## HISTORIC LANDMARK COMMISSION STAFF REPORT

318 6<sup>th</sup> Avenue Avenues Historic District Rear Dormer Window PLNHLC2010-00118 May 19, 2010

This is a request by Ben Shaver, owner, for retroactive approval for minor alterations to a single family residence located at 318 6<sup>th</sup> Avenue in the Avenues Historic District. The request is for an addition of a dormer window to the rear of the property. The property is located in the SR-1A (Special Development Pattern Residential) zoning district.

# Attachment A Application

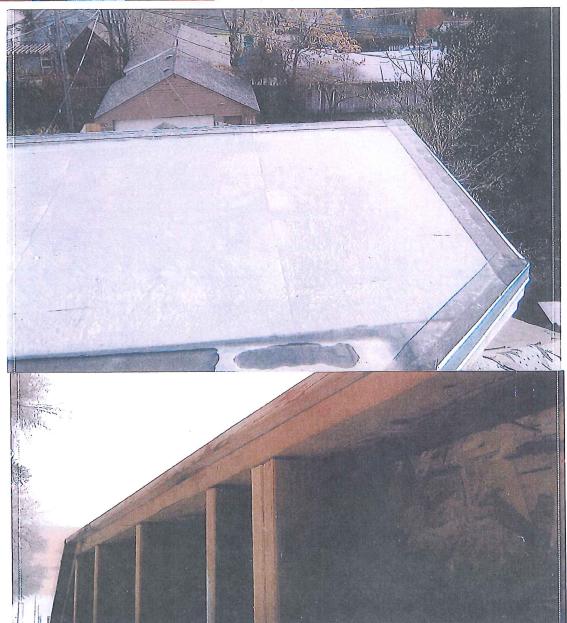
**Analysis:** The property has an original dormer window on both the east and west facing roof slopes. These dormers are gabled, relatively narrow and vertical in proportion. They are in a relatively poor state of repair. The additional dormer to the rear has been constructed with a flat roof and eaves, is larger in dimension and scale, and more square to horizontal in proportion.

**Finding:** In design terms the additional dormer can not be confused as an original feature of the building. The design is not compatible with the size, scale and character of the property. It is however located on the rear south facing roof slope and visible only in oblique views from the street. As such its scale, form and proportions can not be readily appreciated from the public way. It is Staff's opinion that, although this new dormer conflicts with some of the objectives of this standard, the apparent visual impact is minimized by its position, if the standard, as it is applied, is primarily concerned with views from the public way, rather than the integrity of the character of the property.

Analysis: The current dormer window is an addition to rear roof profile of the building. This part of the roof profile remains otherwise intact. The essential form and integrity of the structure would be unimpaired if this element were to be removed in the future. The form and construction of the dormer contrasts with existing design features and the character of the building. The new dormer is not compatible with the building in terms of massing, size, scale and architectural features, as discussed also above in relation to Standard 8.

**Finding:** This standard has three objectives. The first relates to reversibility, and in this respect the dormer window would not conflict with this objective. The second addresses differentiation of new from old, and in this respect the dormer window does not conflict with this objective. The third relates to compatibility and echoes one of the objectives of Standard 8. In various respects the form of this dormer does conflict with the defined objective of this standard, but this effect will be minimized in visual terms in views from the public way due to location.

Analysis: In relation to the Policy statement, the proposed dormer window is an addition to the roof profile of this building, but does not alter the roof profile of the building. In relation to the character discussion on Dormers, the original dormers on the building are vertical in emphasis and are gabled. The recently constructed dormer is square to horizontal in proportion and emphasis. The roof ridge, in this case a horizontal plane, is widened to form the roof of the recent dormer window. The style of the new dormer departs from the style of the house, and introduces a different design element to the building, its roofscape and roofline.

**Findings:** Staff concludes that the dormer would not conflict with the design policy statement. The design of this feature does not accord with the principles in two areas of the character discussion, although there are no design standards to accompany these 'intents'. In the absence of specific standards or guidelines, and in the light of the location of this dormer window, Staff concludes that the adverse impact upon the character of the property would be minimal, as perceived from the public way, and that the proposed dormer could be regarded as acceptable in this case.

Analysis: Although strictly speaking not defined as an "addition" to the building, this section of the Design Guidelines does address the issue of dormer windows and their role in the design of additions, and by reference to design principles, has a bearing on the issue. The recent dormer is an addition to the overall roof mass but, overall, can be defined as subordinate to it. It can not readily be identified as being in scale with the original dormers which characterize this building.

**Finding:** To the extent that this standard is pertinent in this case, Staff would conclude that the dormer does not conflict with the first principle, in that it would not dominate the overall roof mass. Staff would also conclude that the recent dormer does conflict with the second part of the standard, in that it is out of scale with the original dormers on the building, but that the positioning to the rear of the structure minimizes the effect of this discord.

Based on the analysis and findings of this staff report, it is the Planning Staff's opinion that, although the scale, form and design of this dormer window conflicts in part with the objectives of Standards 2, 8 and 9, and in part with the intent or objectives of design guidance relating to Roofs and Dormers, the adverse effects of this dormer addition from the public way will be minimized by its position, and that, if the Commission concurs with these Staff findings, this application be approved.
